ref SB141 Hang Bolt Locking Plate

SERVICE BULLETIN NUMBER 141, Issue 4.

Hang Bolt Locking Plate (modification M308).

Fig 1 twisted lanyard

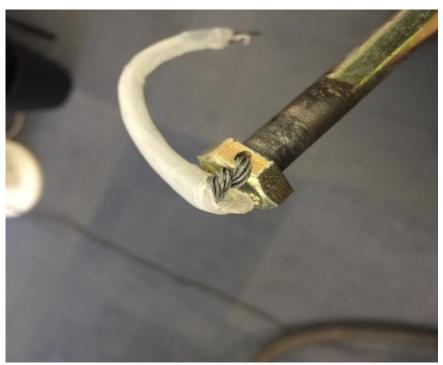
Some instances of the hang bolt head rotating have been found with damage to the safety lanyard. The pinch nut slackens off, promoting wear in the assembly. The bolt rotation is driven by yawing loads between the trike and wing in turbulence.
